Gold Line

BUS RAPID TRANSIT PROJECT • ENVIRONMENTAL ASSESSMENT (EA)
FINDING OF NO SIGNIFICANT IMPACT (FONSI)

ENVIRONMENTAL RE-EVALUATION

August 2020

FIGURE 2-2: 15% DESIGN JOHNSON PARKWAY TO ETNA STATION

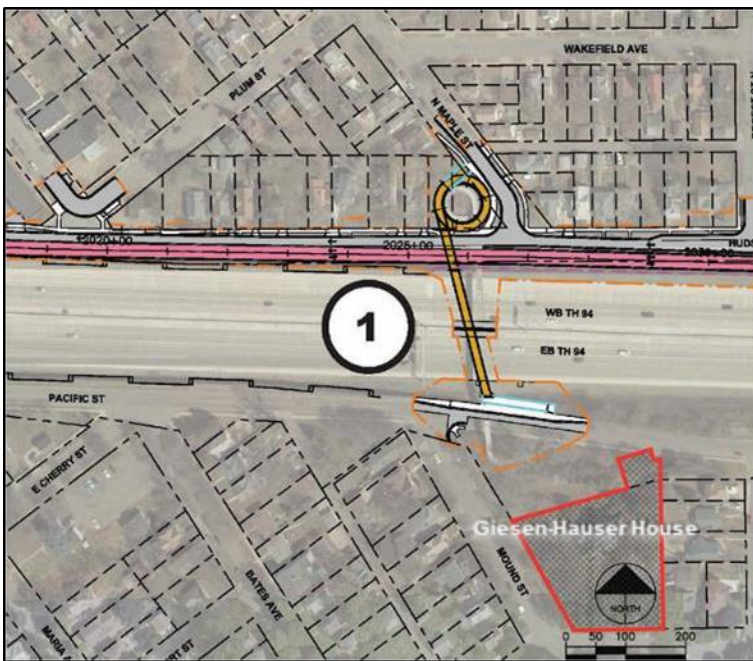
Table 2-2 summarizes long-term impacts to resources potentially affected by the 30 percent design changes for the Maple Street Pedestrian Bridge. Figure 2-2 and Figure 2-3 show 15 percent design and 30 percent design, respectively.

The 15 percent design of the Maple Street Pedestrian Bridge did not impact parking or driveways. The 30 percent design will remove 18 on-street parking spaces on Maple Street and 27 on the north side of Pacific Street. A total loss of 45 on-street parking spaces not previously discussed in the EA/FONSI occurs on roads with low volume traffic in residential areas that typically experience less than 500 vehicles per day. Impacts occur in areas with little residential on-street parking usage. Based on coordination with the City of Saint Paul, no additional mitigation is required.

The Maple Street pedestrian bridge is within Alignment B, which anticipates 8 additional acres of new impervious area. The 15 percent plans replace the existing bridge with no substantially new impervious area. The 30 percent design would add less than 0.01 acre of impervious area for the extended ramps. No additional analysis/mitigation measures is required beyond currently proposed BMPs to account for the small change. The Council will perform hydrologic modeling of the current and proposed conditions as Project design advances to assess the efficiency of the proposed BMPs. Additional rate-control measures, if needed, will be assessed and incorporated into 60% design.

FIGURE 2-4: 15% DESIGN HUDSON ROAD

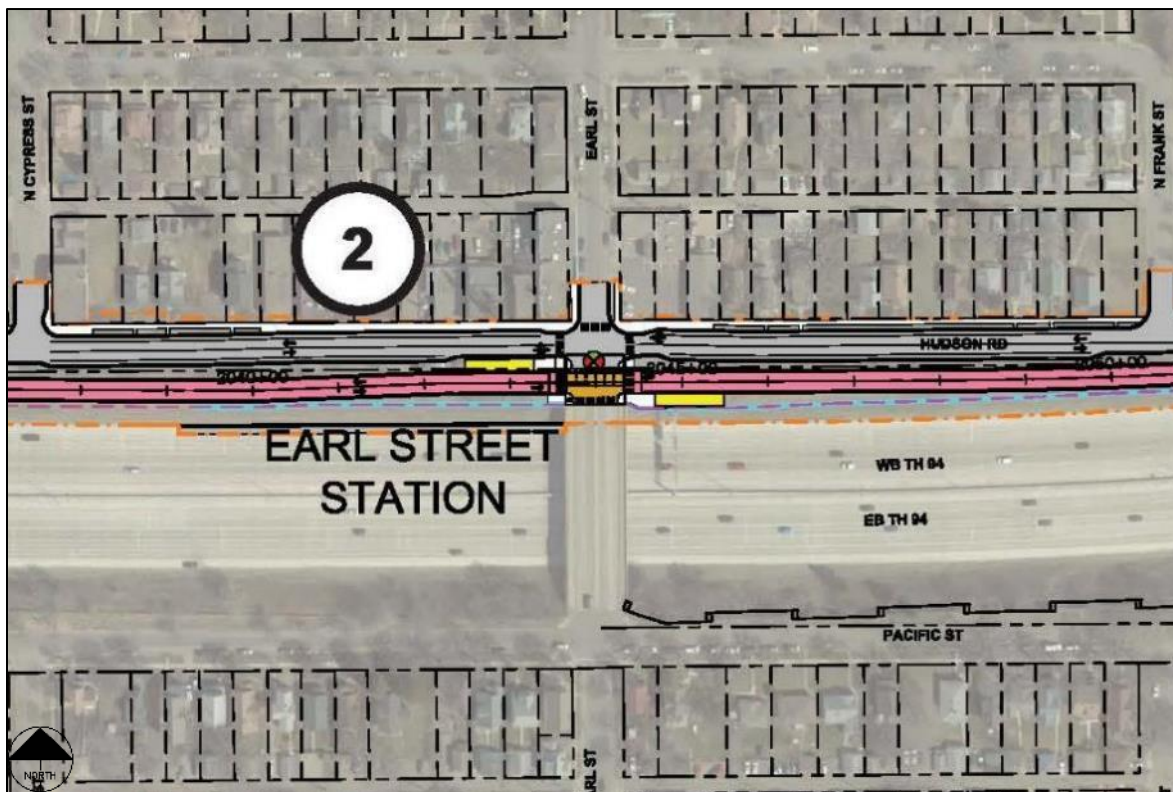
Table 2-3 summarizes impacts to resources potentially affected by the 30 percent design change for Hudson Road between North Cypress Street and North Frank Street. Figure 2-4 and Figure 2-5 show 15 percent design and 30 percent design, respectively.

The 30 percent design will not substantially change the traffic operations reported in the EA/FONSI due to the low traffic volumes on Hudson Road and capacity of the local roadway network to manage diverted traffic from the remaining one-way road section. Traffic operations will be improved by allowing two-way traffic near Earl Street. Traffic between North Cypress Street and North Frank Street can remain on Hudson Road and would not divert to other streets.

The EA/FONSI reported no parking impacts on Hudson Road along the proposed one-way segment. The 30 percent design removes 7 on-street parking spaces. The reduction of seven on-street parking spaces will not affect overall availability of parking, which is available on nearby side streets.

FIGURE 2-6: 15% DESIGN JOHNSON PARKWAY TO ETNA

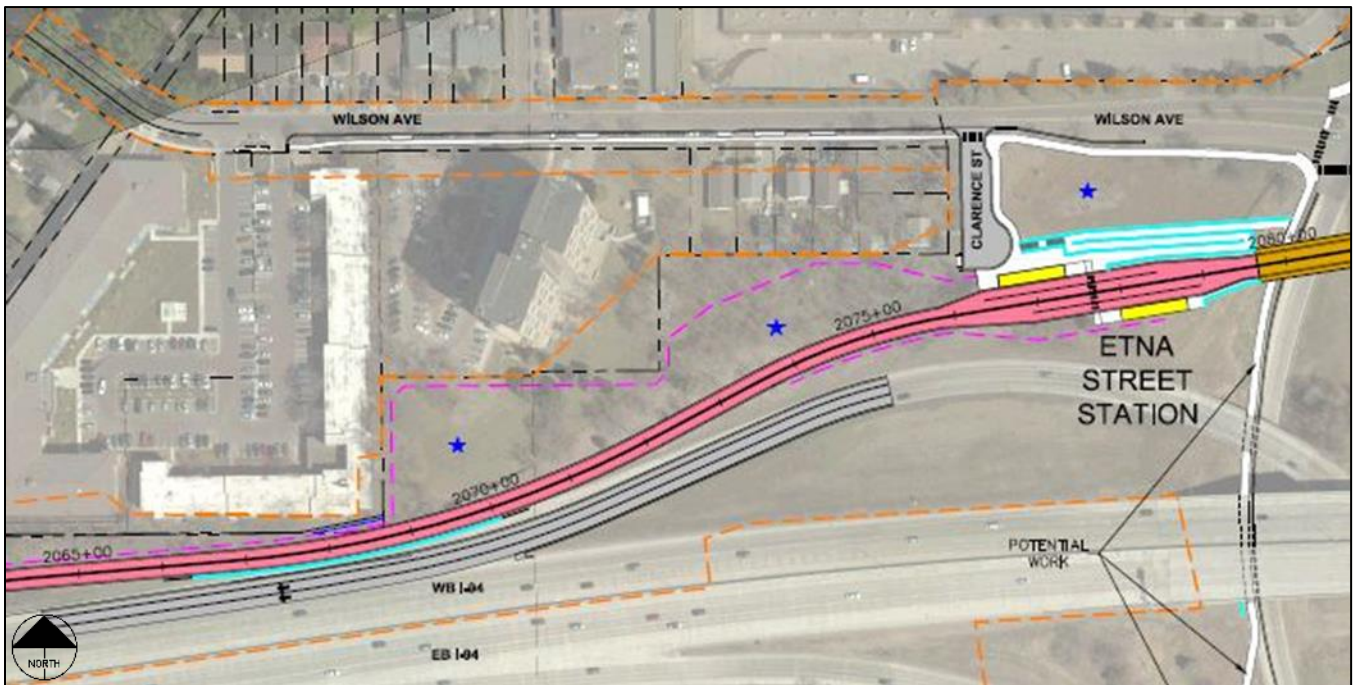
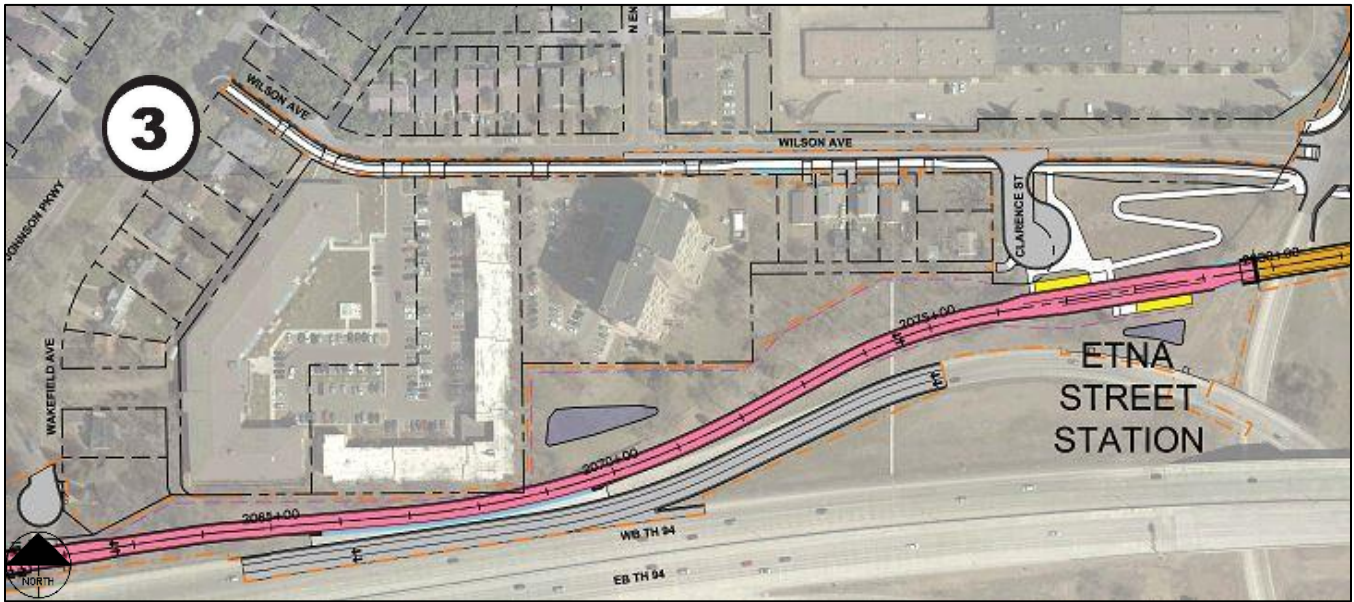
Table 2-4 summarizes impacts to resources potentially affected by the 30 percent design change between Johnson Parkway to Etna Street. Figure 2-6 and Figure 2-7 show 15 percent design and 30 percent design, respectively.

The EA/FONSI reported no parking impacts on Wilson Avenue between Johnson Parkway and Etna Street. The 30 percent design removes 31 on-street parking spaces. The removal of 31 on-street parking spaces occurs on a road with low volume traffic (1,950 ADT, 2018) in a residential area.

FIGURE 2-8: 15% ETNA STREET STATION

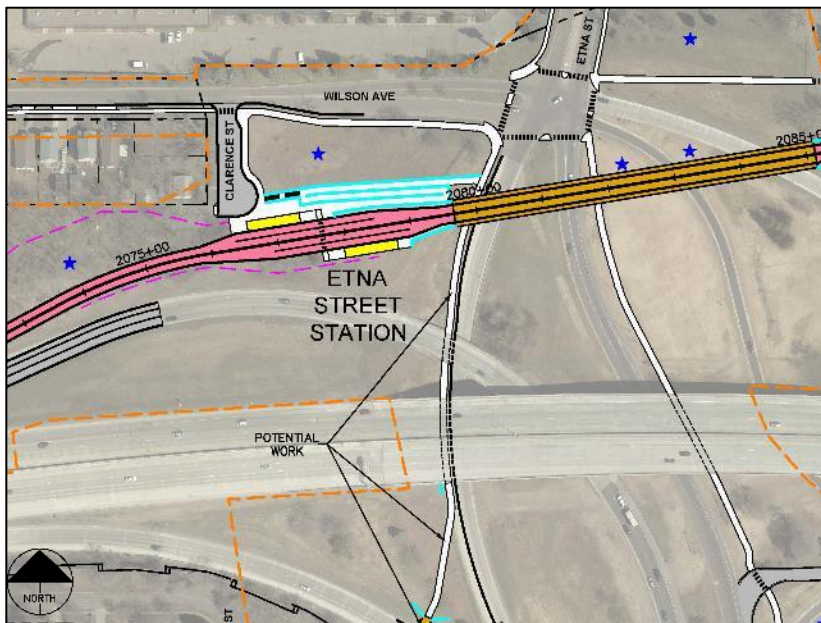
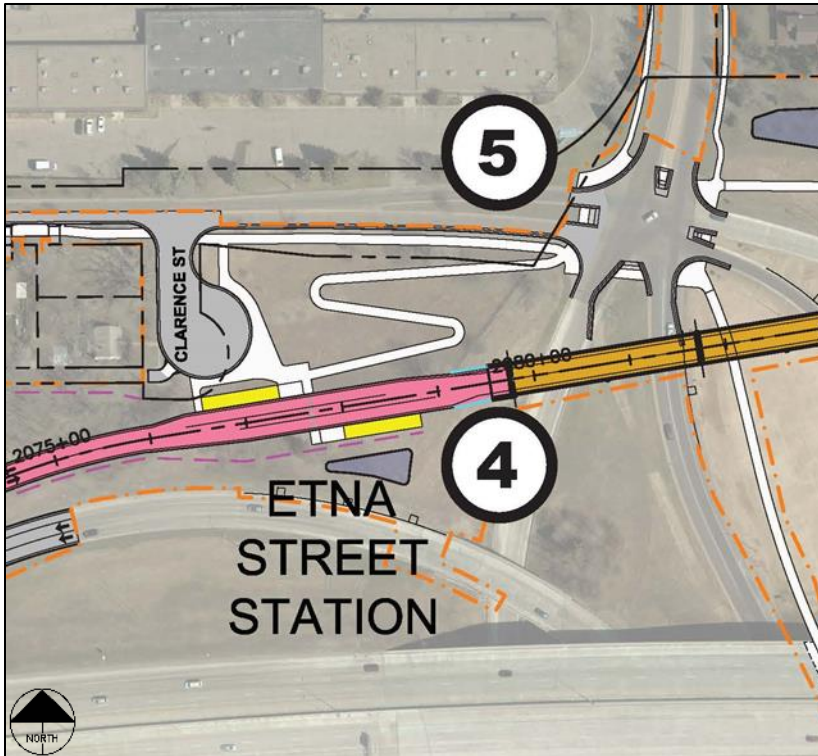
Table 2-5 summarizes impacts to resources potentially affected by the 30 percent design change at the Etna Street Station. Figure 2-8 and Figure 2-9 show 15 percent design and 30 percent design, respectively.

The 15 percent plans in the EA/FONSI indicated the pedestrian/bicycle access ramp would result in views of substantial retaining walls from Wilson Avenue. The 30 percent design removes the retaining walls, which will reduce the visual impact of the pedestrian/bicycle access ramp infrastructure.

FIGURE 2-10: 15% DESIGN ETNA STREET AND WILSON STREET

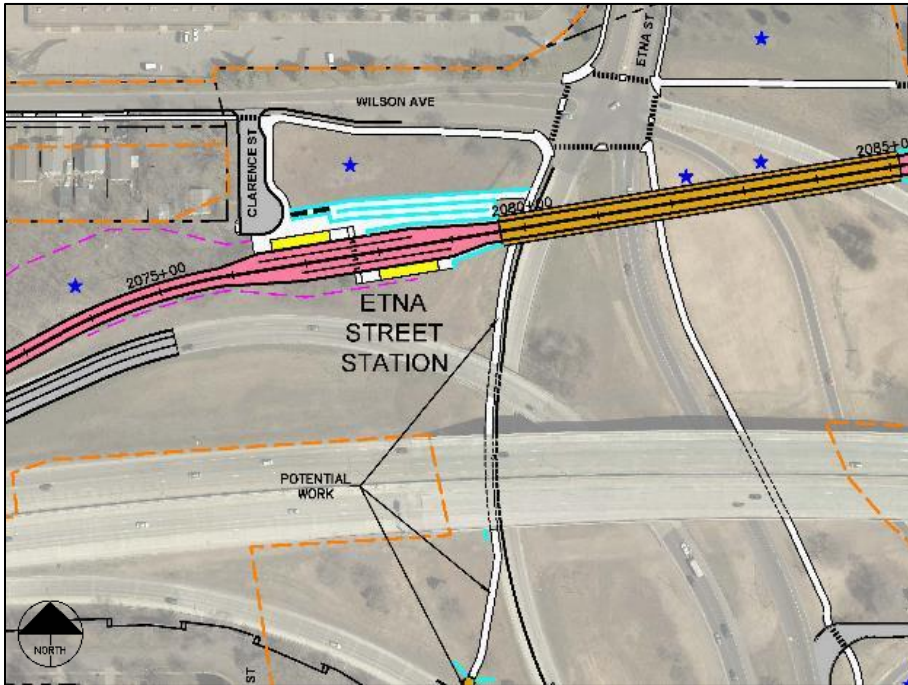
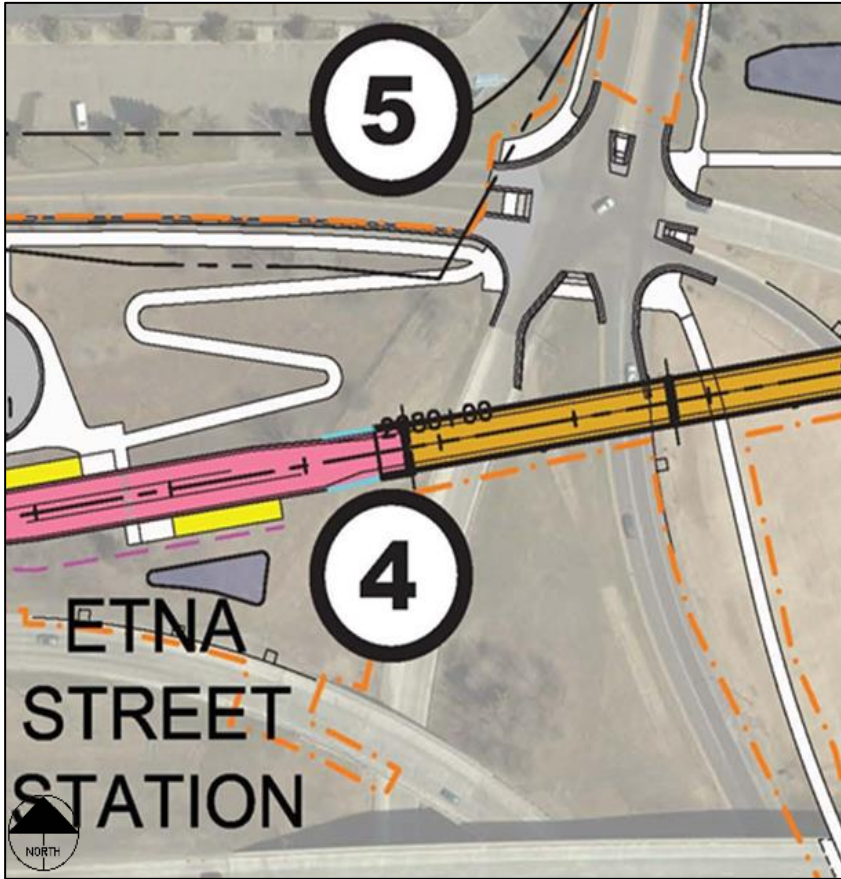
Table 2-6 summarizes impacts to resources potentially affected by the 30 percent design change at Etna Street and Wilson Street. Figure 2-10 and Figure 2-11 show 15 percent design and 30 percent design, respectively.

The EA/FONSI retained the existing eastbound to southbound right-turn movement on Wilson Avenue. Under the 30 percent design, the removal of the right-turn lane from Wilson Avenue will not impact traffic operations due to low traffic volumes on Wilson Avenue. The most recent traffic volumes (2018) on Wilson Avenue are 1,950 vehicles per day (source: MnDOT Traffic Mapping Application). Approximately 340 vehicles per day use the right-turn movement, of which approximately 21 to 27 vehicles per day use the right-turn movement during peak morning and evening travel times.

FIGURE 2-12: 15% DESIGN OLD HUDSON ROAD AND BIRMINGHAM STREET

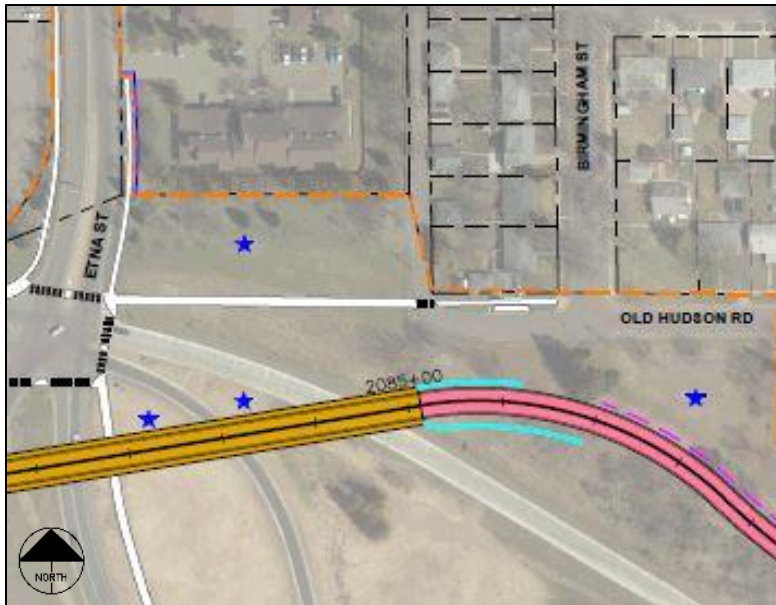
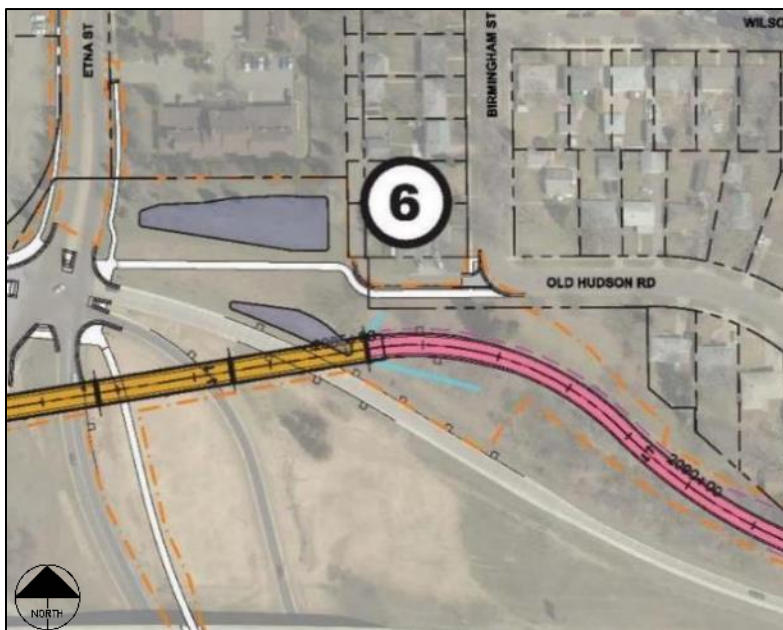
Table 2-7 summarizes impacts to resources potentially affected by the 30 percent design change at Old Hudson Road and Birmingham Street. Figure 2-12 and Figure 2-13 show 15 percent design and 30 percent design, respectively.

The EA/FONSI proposed pedestrian and bicycle connections between Old Hudson Road and TH 61. The 30 percent design still completes pedestrian and bicycle connections to existing sidewalks at Old Hudson Road and Birmingham Street and the Etna Street Station.

FIGURE 2-16: 15% DESIGN MCKNIGHT TRAIL ALIGNMENT ON 3M CAMPUS

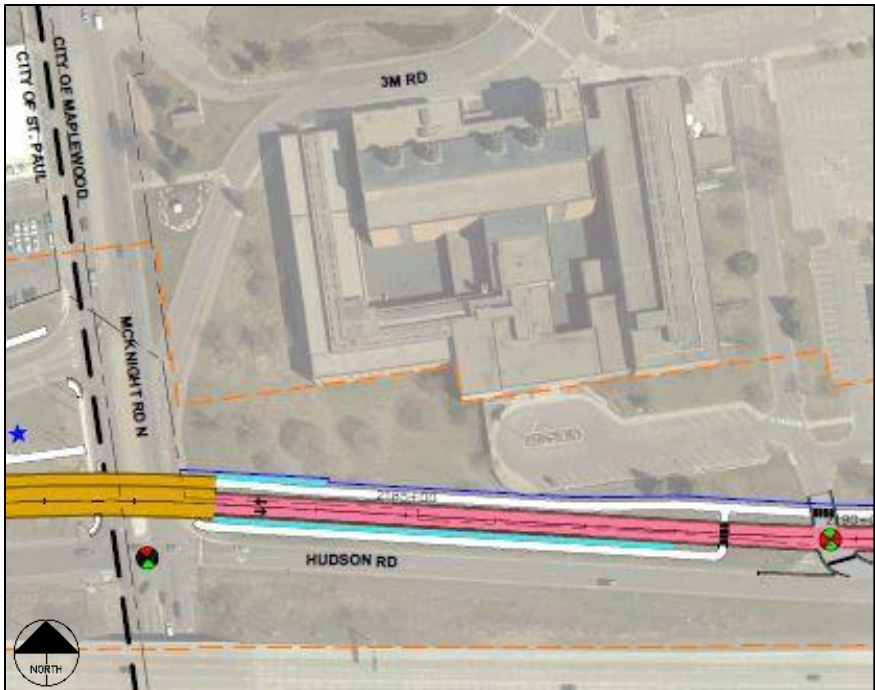
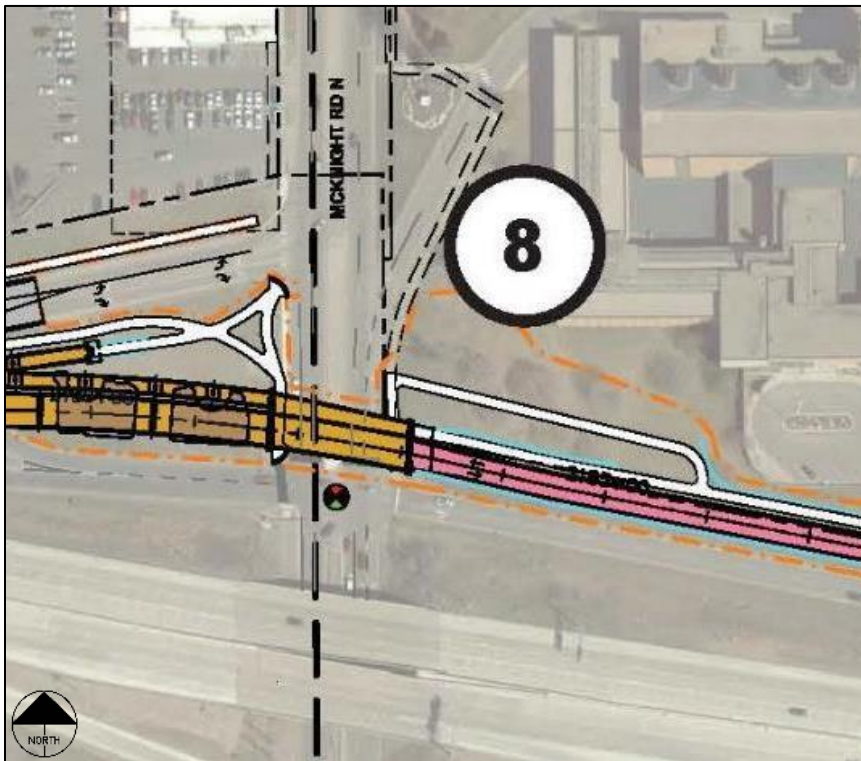
Table 2-9 summarizes impacts to resources potentially affected by the 30 percent design change for the McKnight Trail Alignment on the 3M Campus. Figure 2-16 and Figure 2-17 show 15 percent design and 30 percent design, respectively.

The at-grade pedestrian/bicycle access proposed in the EA/FONSI was eliminated due to City of Maplewood concerns for safety. The BRT bridge crossing McKnight will include a trail to provide grade separated access.

The EA/FONSI indicates the pedestrian/bicycle trail is located within the APE for the historic 3M Campus. The 30 percent design changes are within the APE and the additional acquisition for revised access will respond to the context of the 3M Campus. The assessment of effects on historic properties will be conducted on 30 percent design per the terms of the Project's PA.

FIGURE 2-18: 15% DESIGN EASTERN TRAIL ON 3M CAMPUS

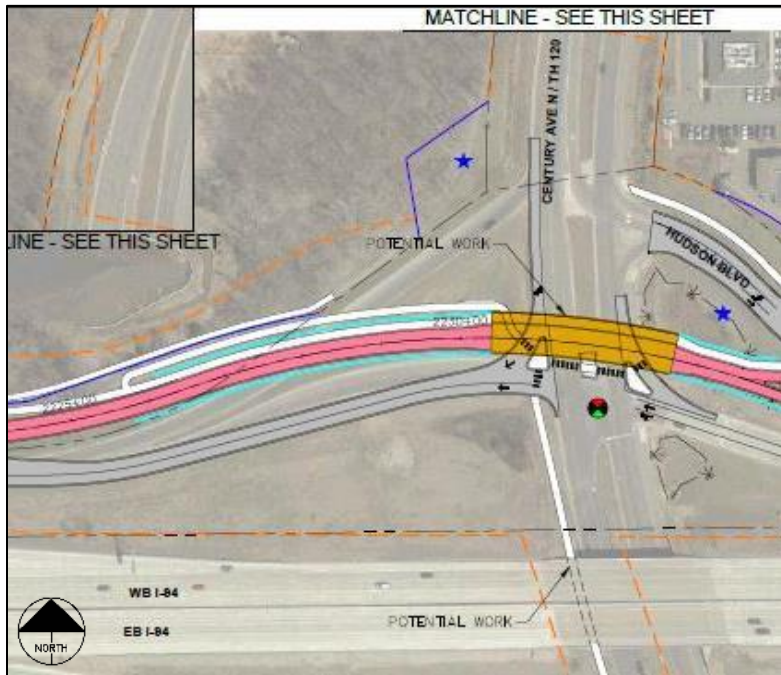
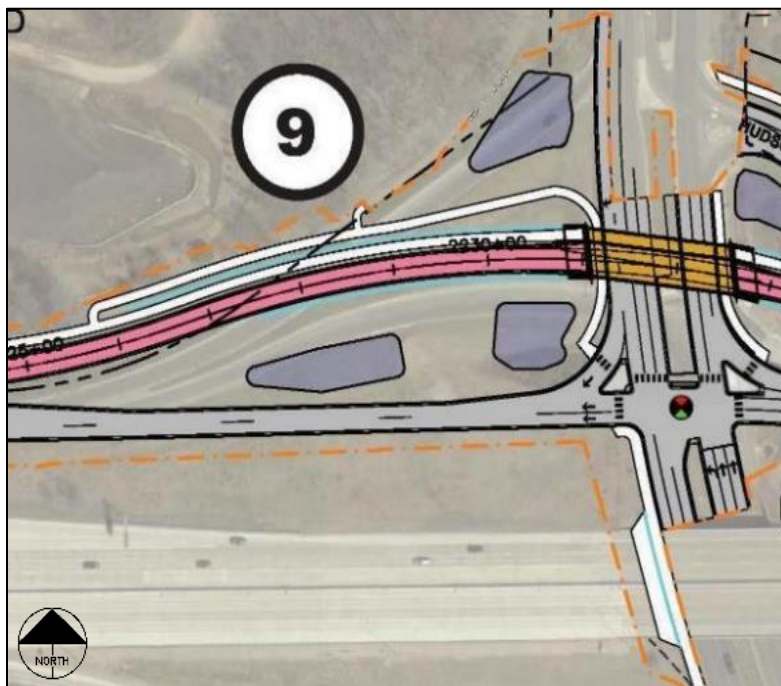
Table 2-10 summarizes impacts to resources potentially affected by the 30 percent design change for the Eastern Trail on the 3M Campus. Figure 2-18 and Figure 2-19 show 15 percent design and 30 percent design, respectively.

The EA/FONSI indicates the pedestrian/bicycle trail is located within the APE for the historic 3M Campus. The 30 percent design modifications are within the APE. The assessment of effects on historic properties will be conducted on 30 percent design per the terms of the Project's PA.
